CGWC-SB-2A

- CGWC-SB-2:** Original issue of bulletin.
CGWC-SB-2A: Added "diagnostic tips" to end of W7900 (1U12) checkout procedure; added new Steps 4 and 5 to W7901 (4U14) checkout procedure, plus additional callouts to Figure 3.

Subject: W7900 and W7901 Control Checkout Procedures
 (for CGAC, CCAC, CGWC, CGRC, CCKC and CGHC Reciprocating Liquid Chillers)

Figure 2
Typical 1U12 Control Module Schematic
for Units with 3- or 6-Step Control

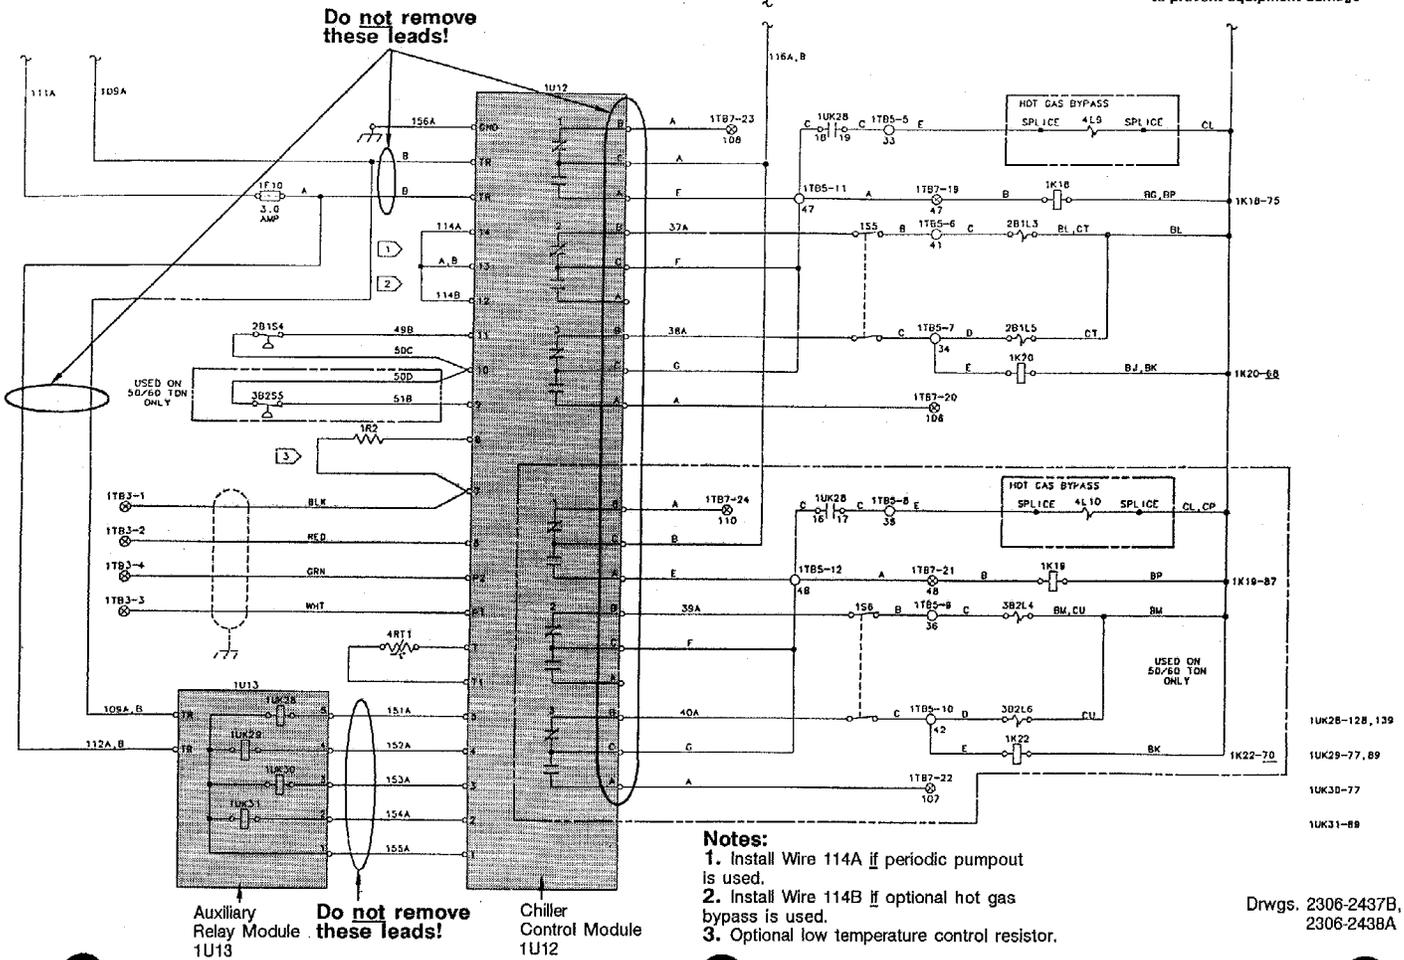
Disconnect Wires 116A and 116B here.

Do not remove these leads!

Do not remove these leads!

Figure 3
Multiple-Unit Controller 4U14
(W7901)

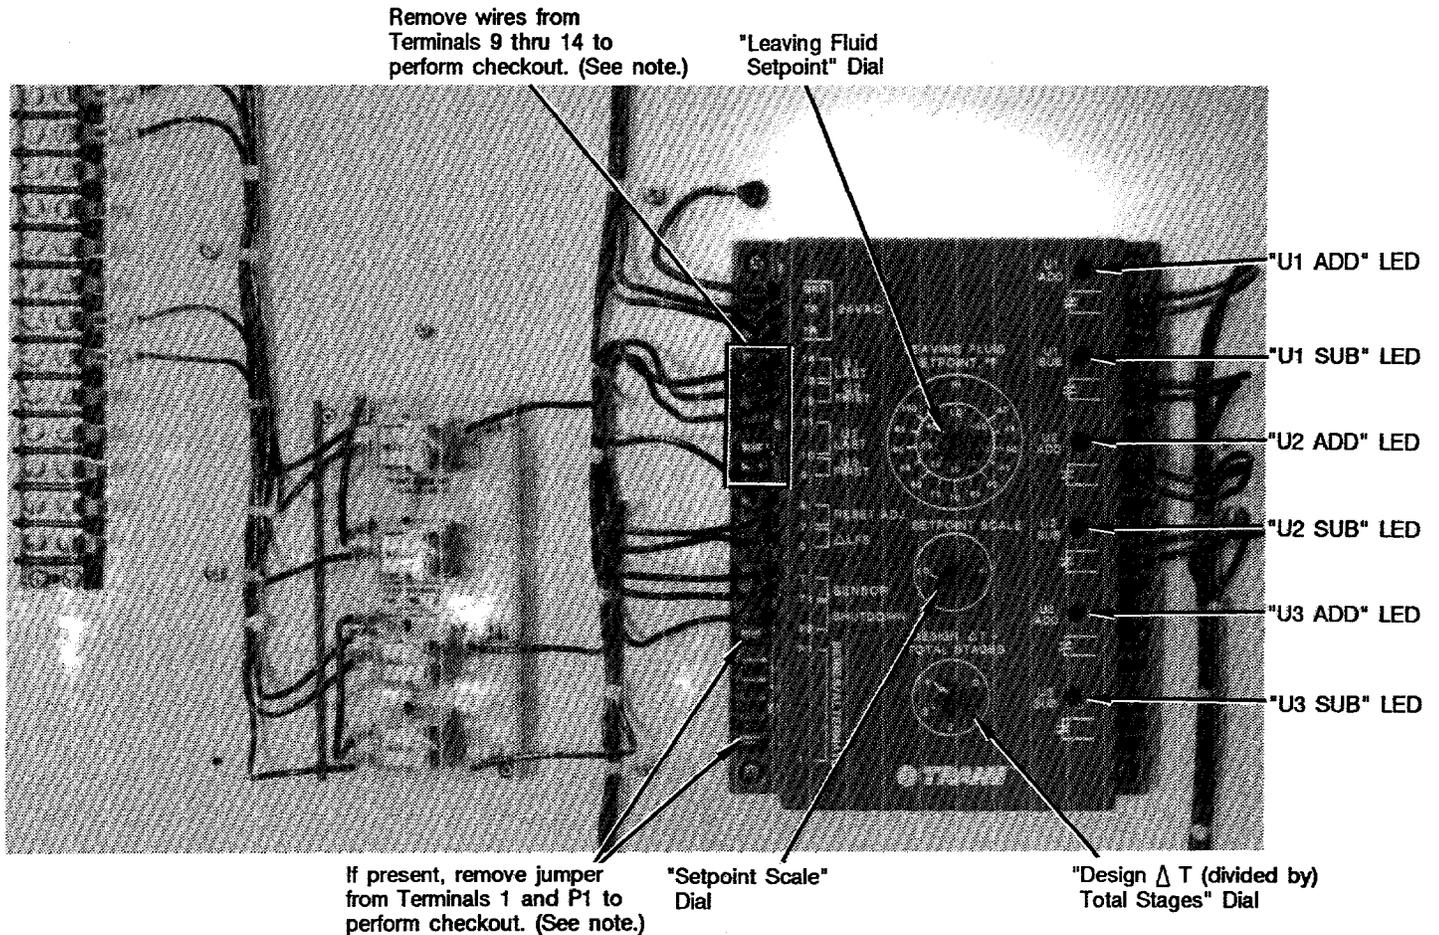
2. Open the main power disconnect of each chiller in the system.
3. Remove the red diagnostic port cover from the bottom of multiple-unit controller 4U14 and insert the diagnostic plug from TOL-0101.
4. Remove the wires connected to 4U14 Terminals 9, 10, 11, 12, 13 and 14; if applicable, remove the jumper connected between 4U14 Terminals 1 and P1, too. See Figure 3.
5. Verify that the MUAA/WA panel's system switch (4S9) is set at RUN, and that service switch 4S8 is set at CONTROLLER ON.
6. Energize the multiple-unit control panel and observe the LED indicator lights; none of the LEDs should be illuminated at this time.
7. Measure the power supply voltage between the 24 VAC input terminals (i.e., Terminals TR and TR) on multiple-unit controller 4U14; the reading obtained should be 25 ± 5 VAC.

Note: If the W7901 module checks out okay, be sure to reconnect the appropriate wires to Terminals 9, 10, 11, 12, 13 and 14; reinstall the jumper between Terminals 1 and P1, if applicable.
